**EASTERN CORRIDOR SEGMENTS II AND III  
Red Bank Corridor to I-275/SR 32 Interchange  
(PID 86462)**

**October 24 and 25, 2018 Public Open House  
CONCEPT EVALUATION and COMMENT SUMMARY**

February 2019

# SR 125/SR 32 FOCUS AREA CONCEPTS A1 AND A2, BOARD 3

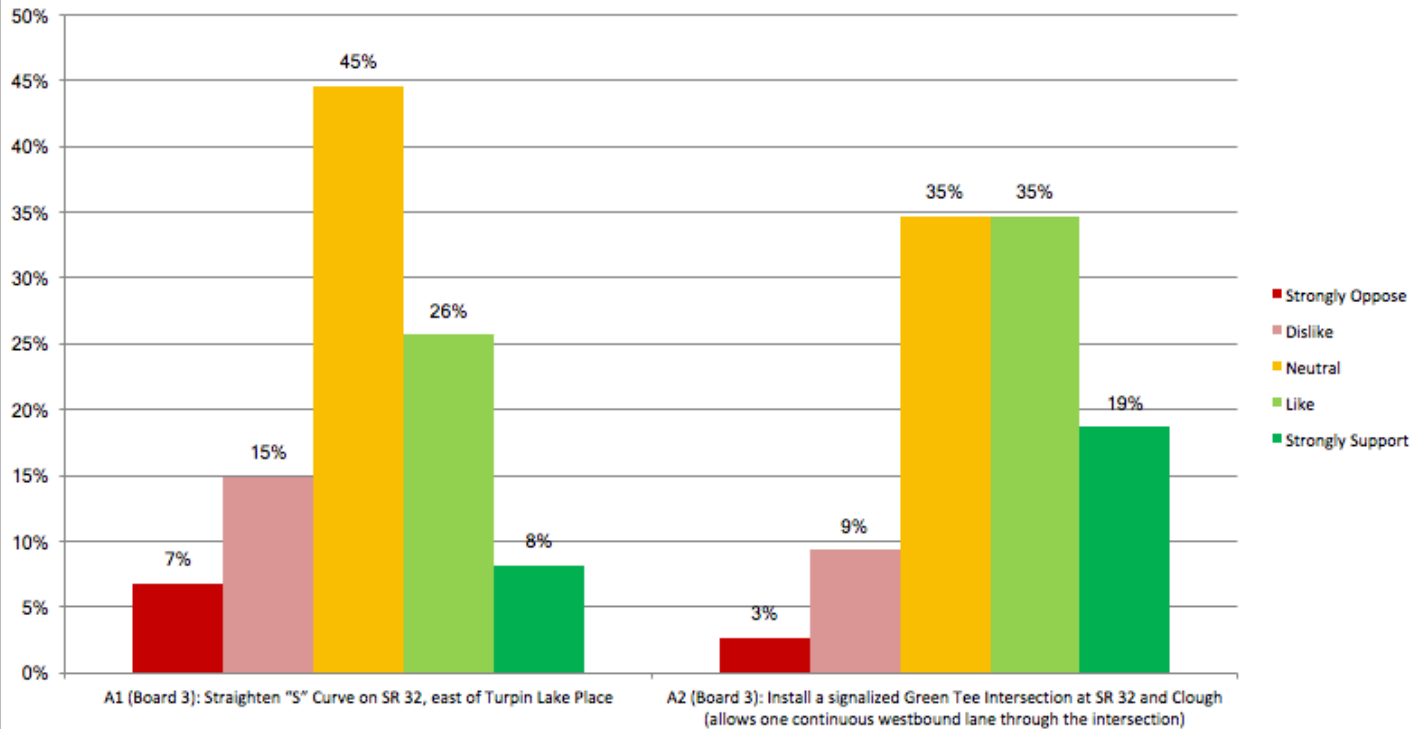
NO.	COMMENT	RESPONSE
1	A1 and A2 encourage speeding through an already fast road. Pedestrian improvements and speed-encouraging improvements are incompatible.	Thank you for your input. If concept A1 were to be advanced, improvements for bicyclists and pedestrians would be limited to providing a safer connection to the bike trail that already runs alongside SR 32 in this area. Currently, this shared-use path is separated from the road by approximately 40 feet. This distance would be maintained if adjustments were to be made to the alignment of the road. Concept A2 is not currently designed to include bicycle/pedestrian improvements because the shared-use path is outside of the proposed project limits. Your comments will be considered as we develop our recommendations.

NO.	COMMENT	RESPONSE
2	A1 seems unnecessary for cost.	Thank you for your comments. Your input is appreciated and will be taken into consideration as we evaluate the options and develop our recommendations.
3	<p><i>Received via email:</i></p> <p>I question if straightening the S curve on SR 32 is a high priority and is worth the cost. It is not that severe a curve. Improving the intersection of Clough and SR 32 is certainly a higher priority and will have more impact. Raising the roadway along that entire section so it doesn't flood and get closed during high water would be helpful. That would need to include doing something about the underpass which easily floods at the SR 32 and SR 125 intersection.</p>	<p>Thank you for your input. One of the primary reasons this concept was proposed was to raise the road out of the floodplain at this location. However, the cost of the project is a concern. When considering next steps, we will be evaluating project benefits vs. the cost as well as public comments before making our final recommendations.</p> <p>We have also been looking at options to address the flooding on the ramp from SR 125 to SR 32. After exploring possible solutions in consultation with the Advisory Committee, we have decided to advance a concept to install a drainage backflow preventer and make some grading adjustments around the bike path to reduce the frequency of flooding under the bridge. These efforts will be incorporated into the Little Miami Scenic Trail (LMST) Beechmont Bridge project (PID 107295) that is scheduled for construction in 2021.</p> <p>Your comments will be considered as we develop our recommendations.</p>

NO.	COMMENT	RESPONSE
1	A1 and A2 encourage speeding through an already fast road. Pedestrian improvements and speed-encouraging improvements are incompatible.	Thank you for your input. If concept A1 were to be advanced, improvements for bicyclists and pedestrians would be limited to providing a safer connection to the bike trail that already runs alongside SR 32 in this area. Currently, this shared-use path is separated from the road by approximately 40 feet. This distance would be maintained if adjustments were to be made to the alignment of the road. Concept A2 is not currently designed to include bicycle/pedestrian improvements because the shared-use path is outside of the proposed project limits. Your comments will be considered as we develop our recommendations.
2	<p><i>Received via email:</i></p> <p>SR 32 and Clough intersection: I am not sure what a Green T intersection is. Adding a lane between Clough intersection and</p>	<p>Thank you for your email.</p> <p>A Green Tee intersection is a three-way intersection that allows one direction of main line through-traffic to pass through a signalized intersection without stopping (the</p>

NO.	COMMENT	RESPONSE
	<p>Speedway is a good idea which will definitely help west bound traffic. Not sure it will do much to help eastbound SR 32 traffic which will still need to wait at the light. The money allocated to the A1 section above (straightening S curve) might be better used to create a ramp from west bound Clough onto Westbound SR 32.</p>	<p>top side of the "T"), while all other traffic movements would be signalized. At this location, the westbound traffic on SR 32 would bypass the signal.</p> <p>An earlier concept did review adding a ramp from westbound Clough to westbound SR 32 that was grade separated, but the Advisory Committee did not advance this alternative due to higher cost compared to the Green Tee and the Green Tee also allows for a left turn from westbound SR 32 to eastbound Clough, which is currently a prohibited movement.</p> <p>We appreciate your other comments and will take them into consideration as we develop our recommendations.</p>

## SR 125/SR 32 FOCUS AREA CONCEPTS A3 AND A4, BOARD 4

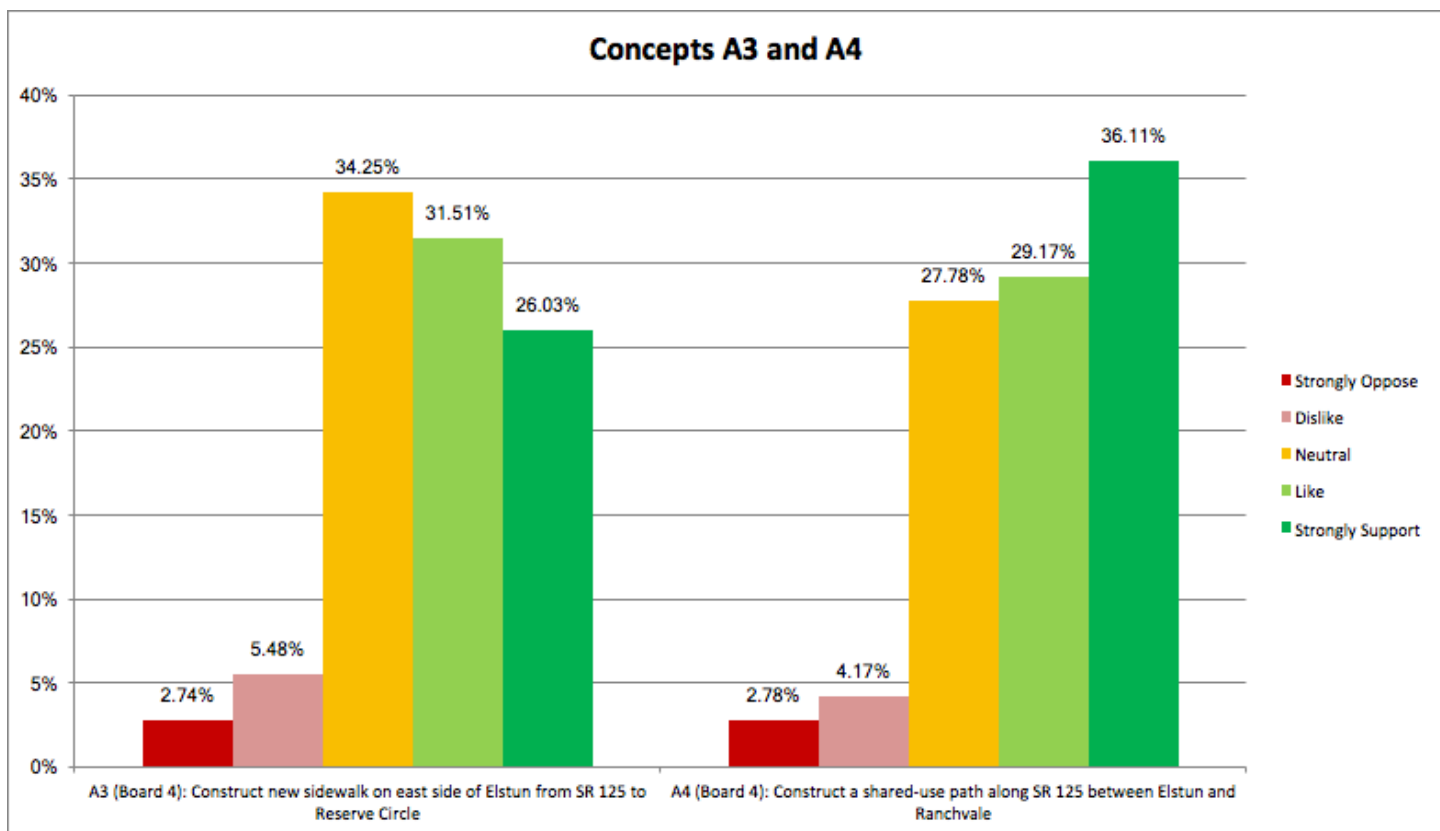
NO.	COMMENT	RESPONSE
1	A3 - Minor construction cost for major pedestrian safety improvement for residents on Elstun.	Thank you for your comments. Your input is appreciated and will be taken into consideration as we evaluate the options and develop our recommendations.

NO.	COMMENT	RESPONSE
1	A4 - Not a need.	Thank you for your comments. Your input is appreciated and will be taken into consideration as we evaluate the options and develop our recommendations.
2	A4 - This stretch of road is unsafe for pedestrians and bike riders because of high speed of traffic through the corridor that is encouraged by the "highway feel" of the large neighborhood roadway.	Thank you for your comments. Your input is appreciated and will be taken into consideration as we evaluate the options and develop our recommendations.
3	I am very concerned about the shared use path along Beechmont Avenue between Elstun Road and Ranchvale requiring additional right of way. Currently, a bike lane and buffer are paved. Why can the curb not be moved inward, and use the existing right-of-way? I also have a large concern about nothing being done to calm traffic at the intersection of Elstun and Beechmont.	<p>Thank you for your input.</p> <p>The purpose of this proposed path is to provide slower-moving bicyclists and pedestrians with safer space to travel in. While a bike lane is currently provided, it has been noted that only seasoned bicyclists are comfortable using it due to the grade and proximity to traffic. The shared-use path offset from the roadway could provide a more family-friendly connection.</p> <p>ODOT and the Advisory Committee members share your concerns about traffic at Elstun and Beechmont. Due to near-term redevelopment discussions at the Skytop site, it was not prudent to make changes at this intersection without understanding new traffic demands and patterns. Though concepts are not being advanced as part of the Eastern Corridor series of projects, it remains an issue that Anderson Township and other local jurisdictions will be looking to address as redevelopment plans are finalized.</p> <p>Your comments will be considered as we develop our recommendations.</p>

## SR 125/SR 32 FOCUS AREA CONCEPTS A5 AND A6, BOARD 5

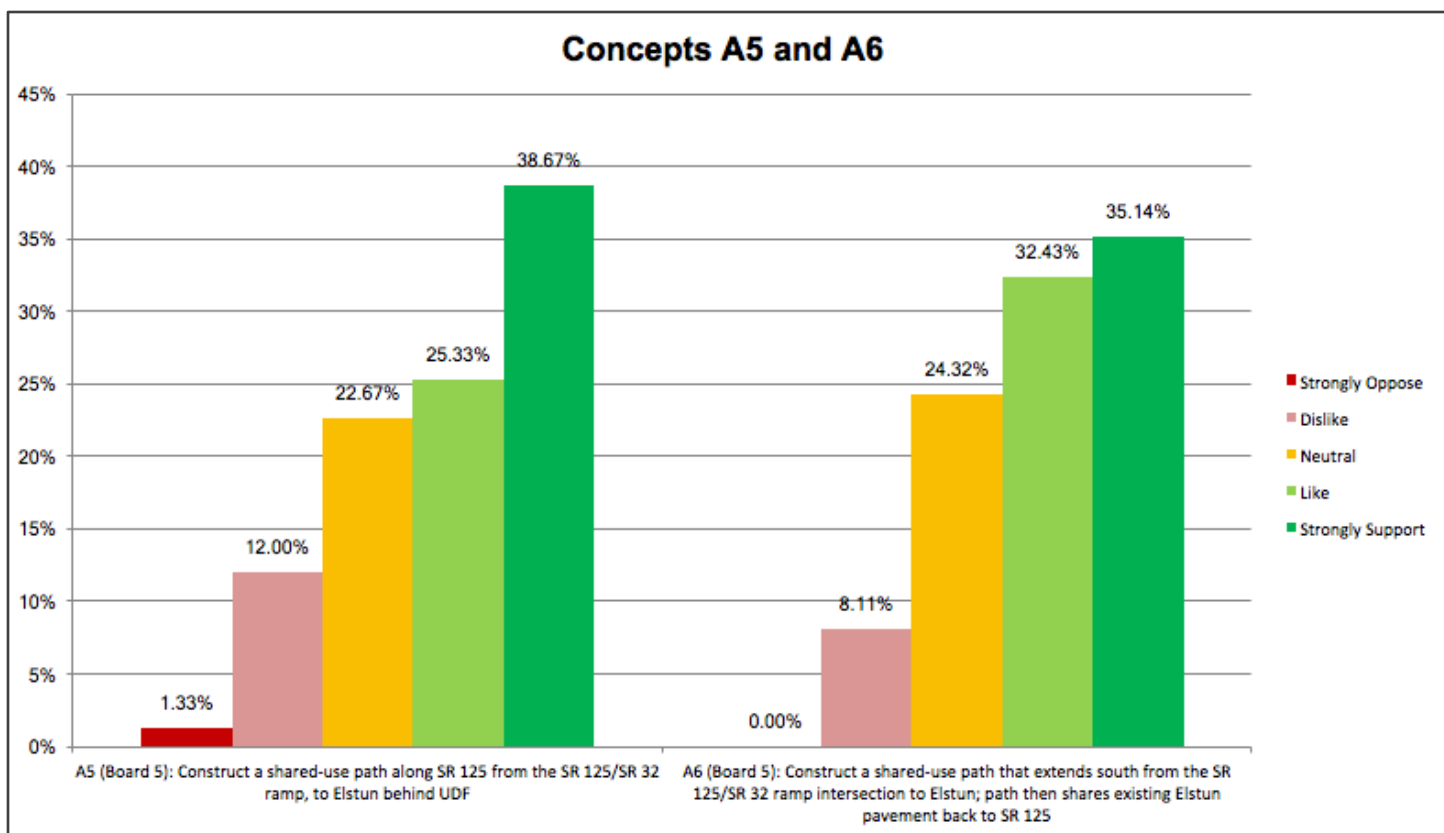
NO.	COMMENT	RESPONSE
1	A5 - Why is this connection needed?	Thank you for your question. The purpose of this connection is to provide bicyclists and pedestrians with a safe connection between Elstun and the Little Miami Trail without needing to travel with vehicular traffic on SR 125.
2	Prefer A5 over A6 to make direct connection to Beechmont bike lanes.	Thank you for your comments. Your input is appreciated and will be taken into consideration as we evaluate the options and develop our recommendations.
3	A5 and A6 - Providing a connection to the Ohio River bike trail network would allow an entire neighborhood to access this bikeway without vehicle travel. Major quality of life improvement and opens the	Thank you for your comments. Your input is appreciated and will be taken into consideration as we evaluate the options and develop our recommendations.

NO.	COMMENT	RESPONSE
	door for potential bicycle commuting. A5 would be more accessible and safer to use.	
4	Connecting the bottom of the Beechmont hill (i.e. UDF, Skytop Pavilion area) to Lunken/Little Miami Trail is most desired to keep cycling off of Beechmont levee and ramps to/from Route 32.	Thank you for your comments. Your input is appreciated and will be taken into consideration as we evaluate the options and develop our recommendations. Based on public comment and Advisory Committee discussions, Concept A6, discussed below, was revised to provide a separate shared-use path connection along Elstun.

NO.	COMMENT	RESPONSE
1	Prefer A5 over A6 to make direct connection to Beechmont bike lanes.	Thank you for your comments. Your input is appreciated and will be taken into consideration as we evaluate the options and develop our recommendations.
2	<p>A5 and A6 - Providing a connection to the Ohio River bike trail network would allow an entire neighborhood to access this bikeway without vehicle travel. Major quality of life improvement and opens the door for potential bicycle commuting. A5 would be more accessible and safer to use.</p> <p>If A6 is moved forward, can A3 be converted to mixed use trail and extended further down Elstun to avoid a shared roadway?</p>	<p>Thank you for your comments. Your input is appreciated and will be taken into consideration as we evaluate the options and develop our recommendations.</p> <p>Based on public comment and Advisory Committee discussions, Concept A6 will be revised to provide a shared-use path connection along the entire length without using a shared roadway segment. The sidewalk connection along Elstun proposed in Concept A3 would be replaced by the shared-use path.</p>

# SR 125/SR 32 FOCUS AREA CONCEPTS A7 AND A8, BOARD 6

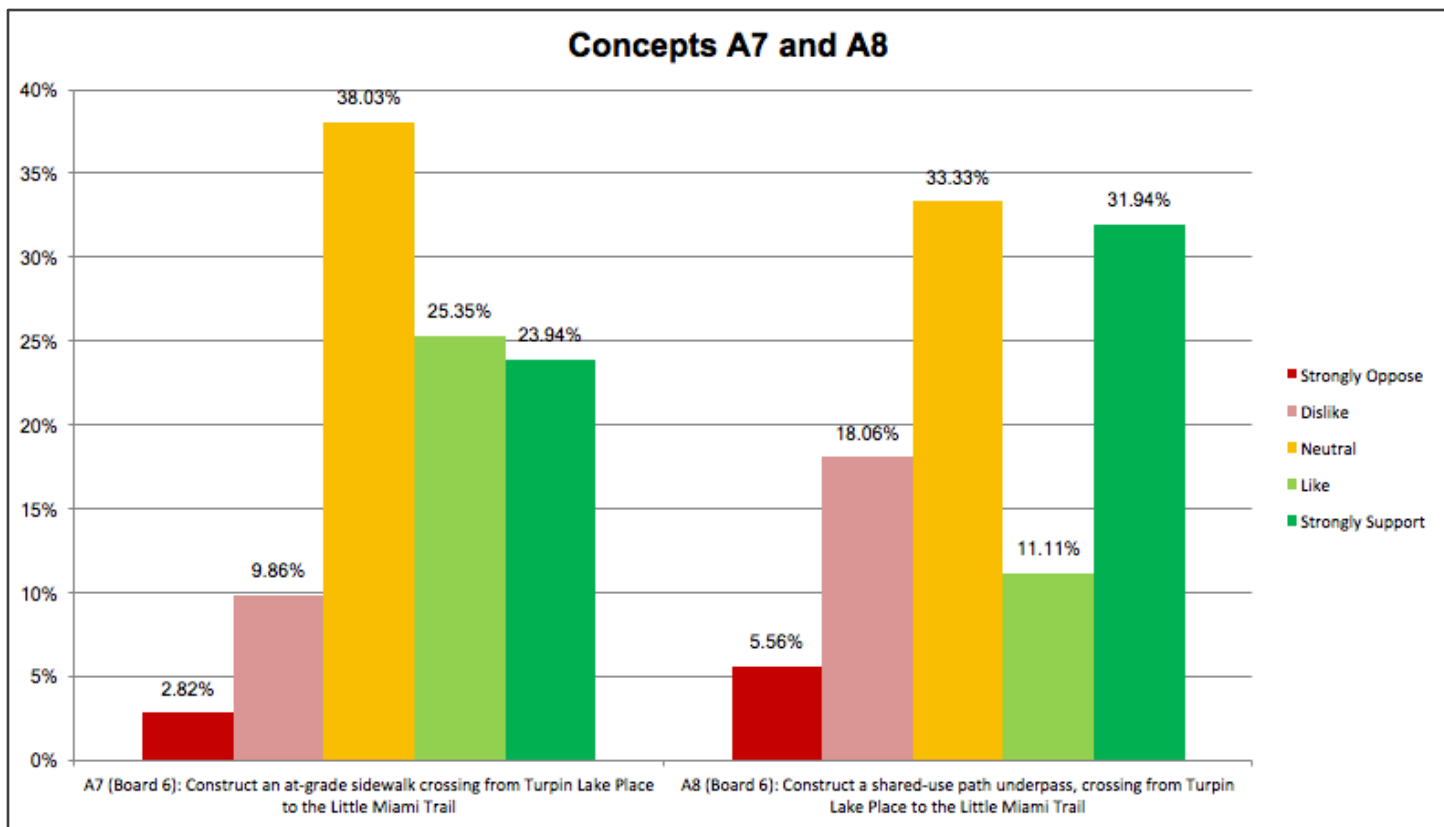
NO.	COMMENT	RESPONSE
1	A7 - How many pedestrians impacted here?	Thank you for your question. This concept would most likely be advanced in coordination with concept A9 which would establish a new bike/pedestrian connection between the Five Mile Trail and the Little Miami Trail using the streets in the Turpin Hills neighborhood. The A7 connection would be used to cross SR 32 to the Little Miami Trail, therefore, a higher level of use beyond the residents in houses located on Turpin Lake Place would be expected. A projection of the number of anticipated users has not yet been developed.
2	A7 - This pedestrian crossing will be creating a major safety hazard. There is no way drivers will yield to a pedestrian signal while traveling 50+mph through this	Thank you for your comment. ODOT and the SR 125/SR 32 Advisory Committee have discussed similar concerns. Should this concept be advanced, the group discussed completing a speed study to determine if a lower speed limit along SR 32 would be warranted. This would need to

NO.	COMMENT	RESPONSE
	area especially if the roadway is straightened.	be further explored before making any decisions to construct the project.
3	A7 - 50,000 for a sidewalk? For 15 houses?	Thank you for your comment. This concept would most likely be advanced in coordination with concept A9 which would establish a new bike/pedestrian connection between the Five Mile Trail and the Little Miami Trail, using the streets in the Turpin Hills neighborhood. The A7 connection would be used to cross SR 32 to the Little Miami Trail, therefore, a higher level of use beyond residents in the houses located on Turpin Lake Place would be expected. Your input will be taken into consideration as we develop our recommendations.

NO.	COMMENT	RESPONSE
1	A8 - Major investment to benefit minimal number of residents even if A9 is carried forward. This alternative is considered a primary need versus the Elstun bikeway connection is considered secondary which would serve the entire neighborhood of Mt Washington. This need designation does not make sense.	Thank you for your comment. As you noted, this concept would most likely be advanced in coordination with concept A9 which would establish a new bike/pedestrian connection between the Five Mile Trail and the Little Miami Trail, using the streets in the Turpin Hills neighborhood. The A7 connection would be used to cross SR 32 to the Little Miami Trail, therefore, a higher level of use beyond residents in the houses located on Turpin Lake Place would be expected. Your input will be taken into consideration as we develop our recommendations.
2	<i>Received via email:</i>  A8 - An overpass instead of an underpass would make more sense since that area floods.	Thank you for your comment.  Typically, an overpass carries a much higher cost and tends to be under-utilized as users choose to not use stairs or ADA compliant ramps to go up and over. Since the roadway concept in this area also is addressing flooding by raising the roadway, the added elevation provides an opportunity for the underpass.

# VILLAGE OF NEWTOWN FOCUS AREA CONCEPTS B1 AND B2, BOARD 9

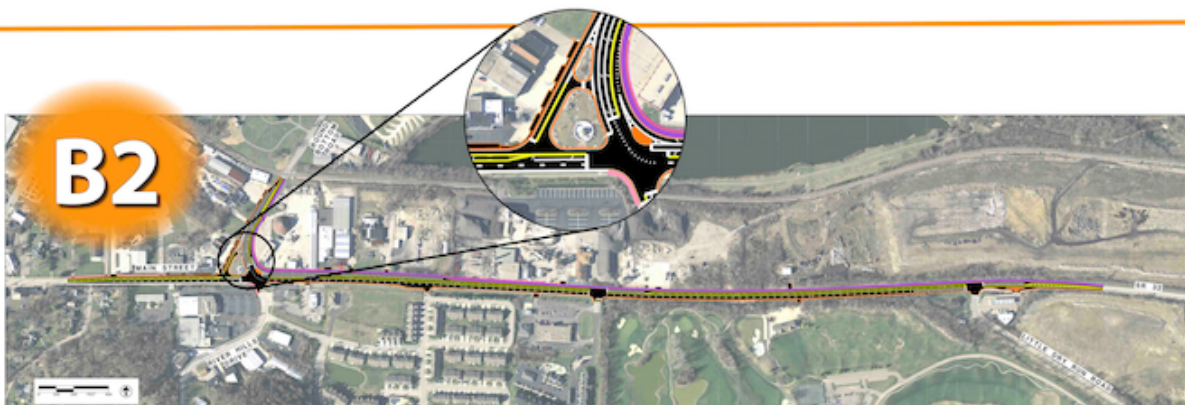
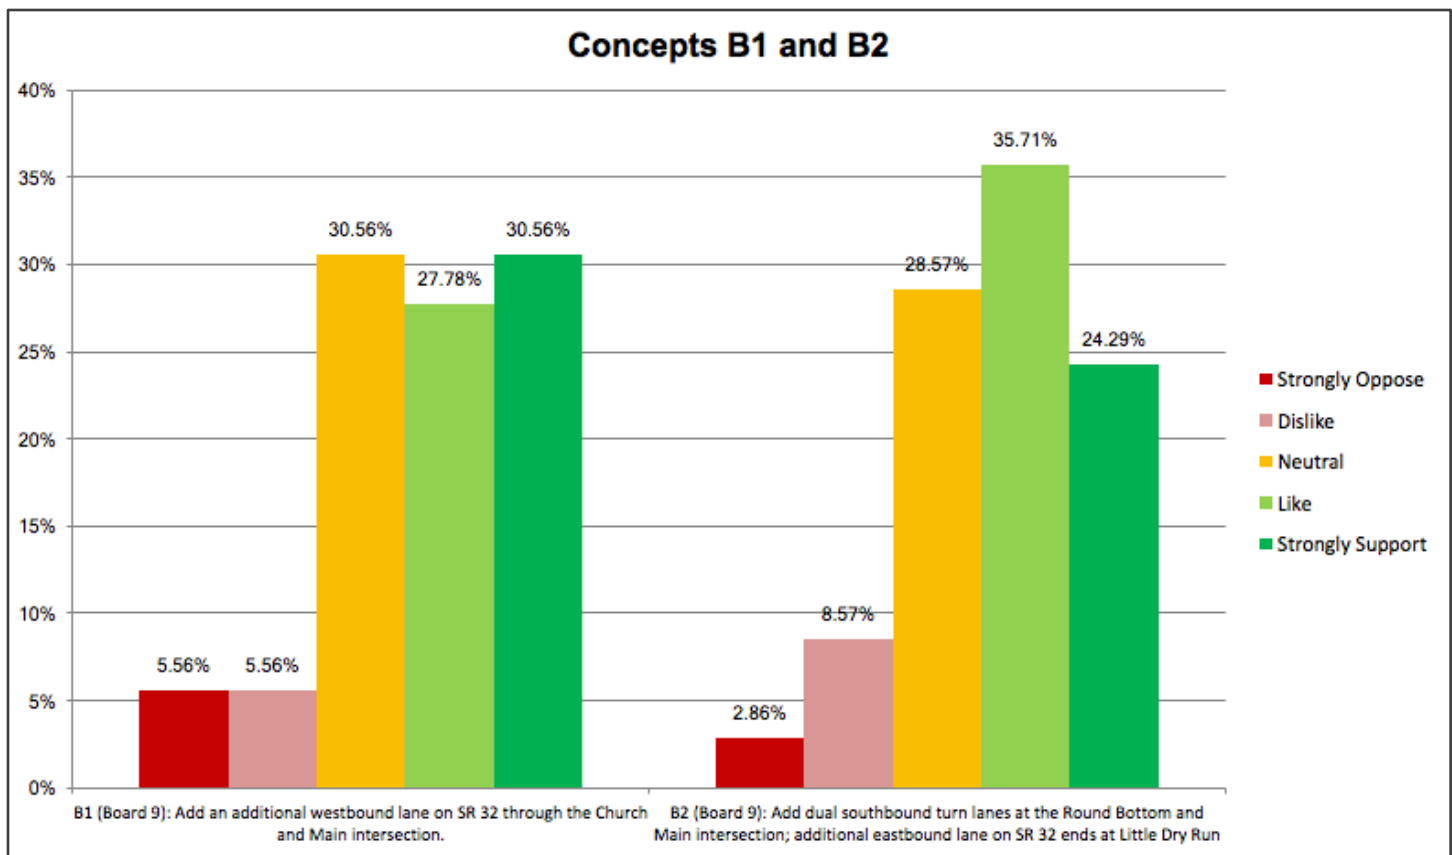
NO.	COMMENT	RESPONSE
1	B1 - Would destroy walkability and historic feel of Newtown.	Thank you for your comment. This has been a concern of the Advisory Committee as well and maintaining walkability has been identified as a priority. We will keep this aspect in mind as we develop recommendations to be included in the Implementation Plan. Also, additional community involvement will be necessary before any final decisions regarding construction are made.
